February 19, 1988 ST-HL-AE-2530 File No.: GO2 10CFR50.

South Texas Project Electric Generating Station
Unit 1
Docket No. STN 50-498
Main Feedwater Hydraulic Transients
-Additional Information-

Attachment 2

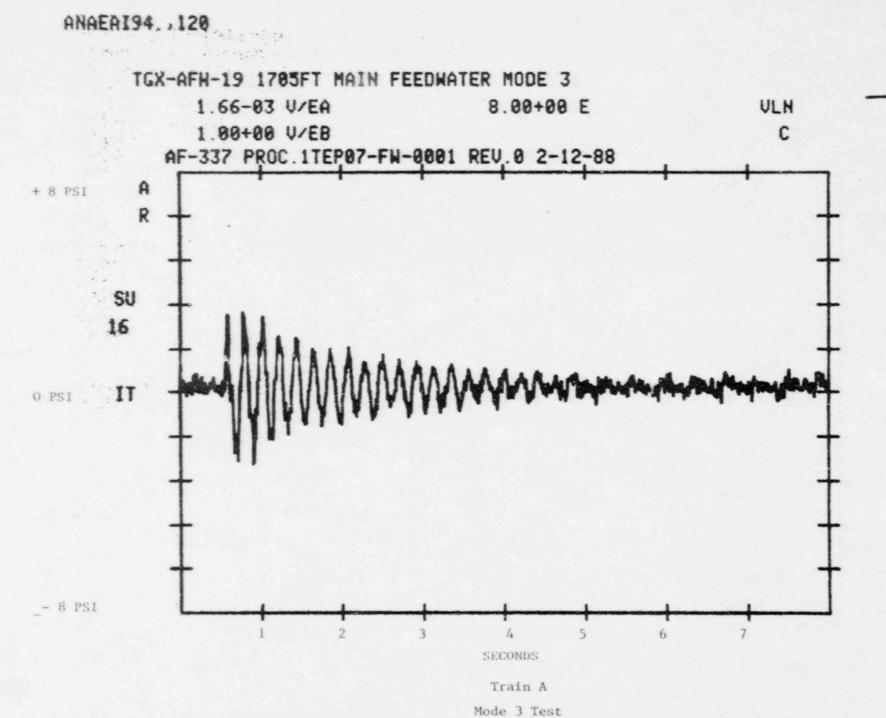
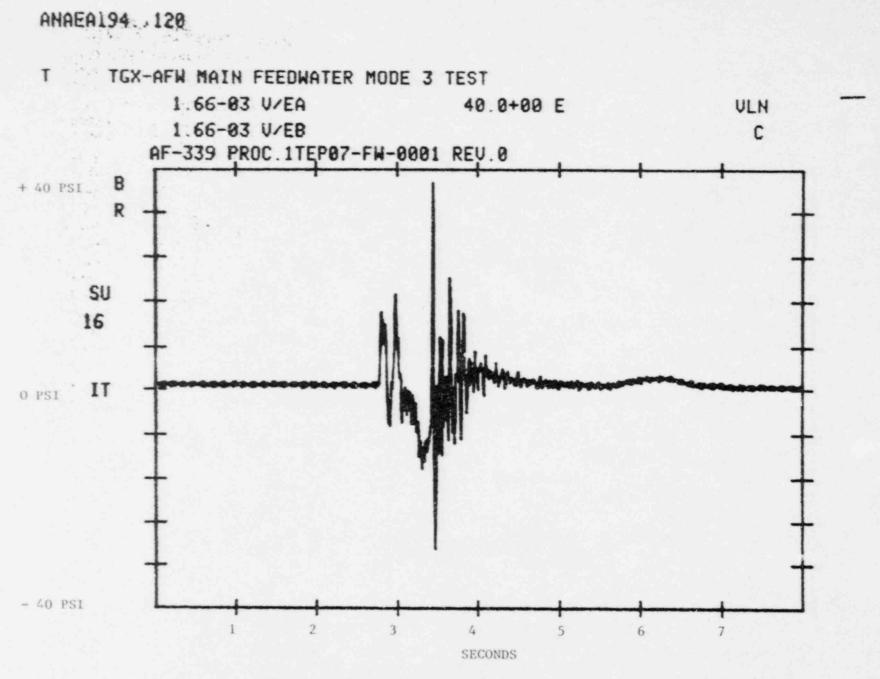
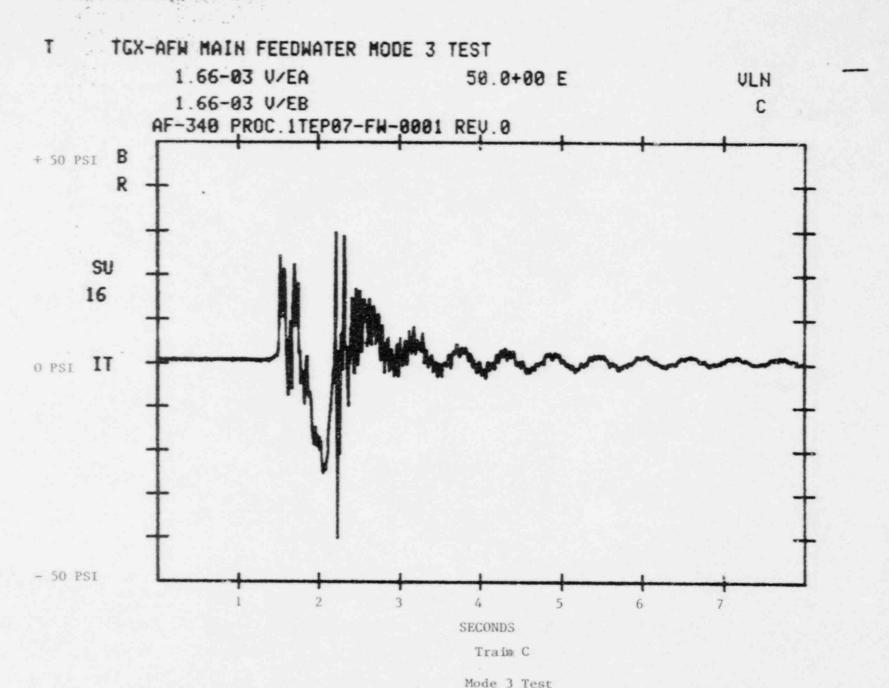
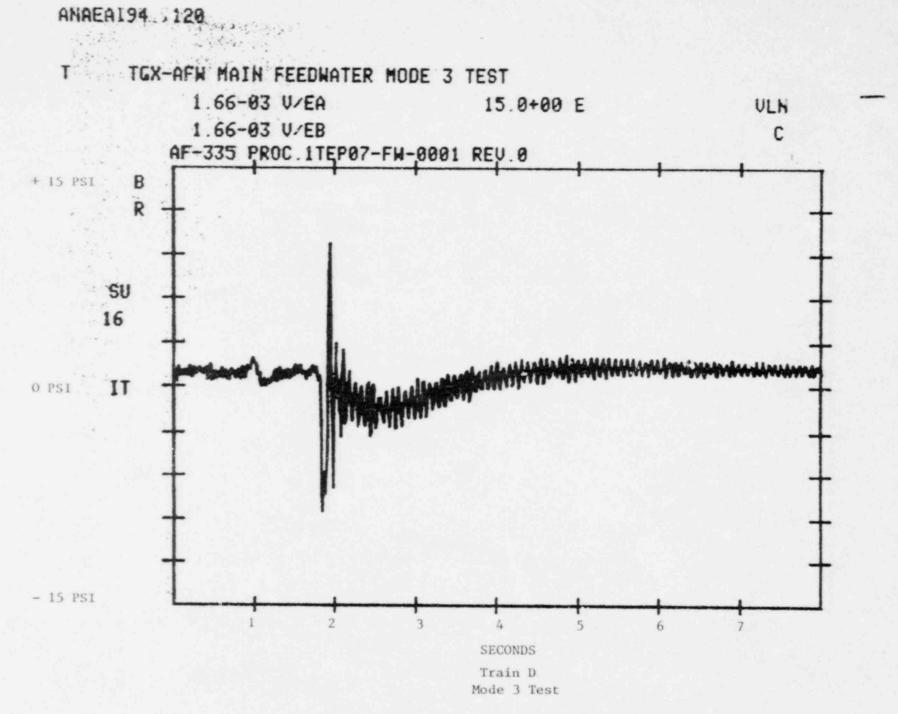
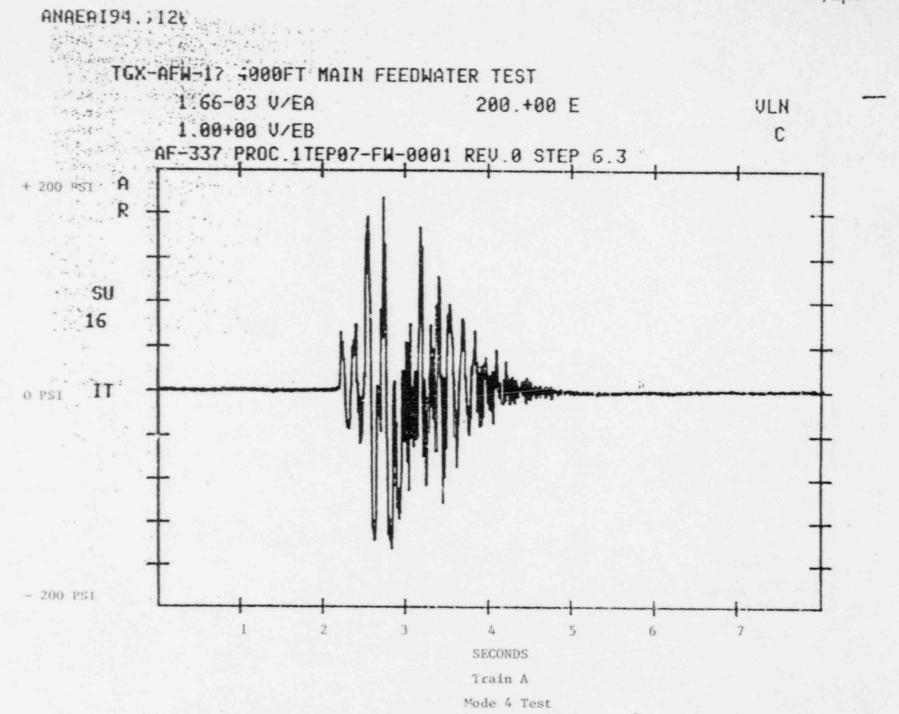
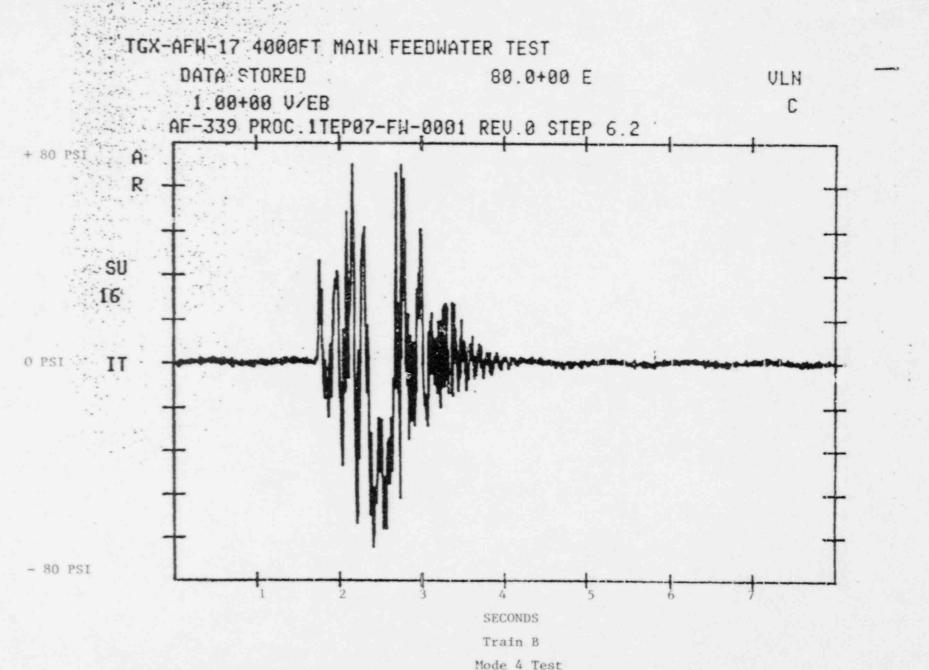
NRC Request #2 - Provide Test, Analysis and Measurement Unit (TAMU) data on Mode 3 and 4 tests while feeding through the upper nozzle.

Response - Attachment 2 (Pages 1 through 8) provides data of pressure readings that were taken during Mode 3 and Mode 4 tests at the drain valves downstream of the tie-in points of the preheater bypass line to the auxiliary feedwater line when flow was initiated through the upper steam generator nozzles. These pressure readings do not reveal any abnormal transients.
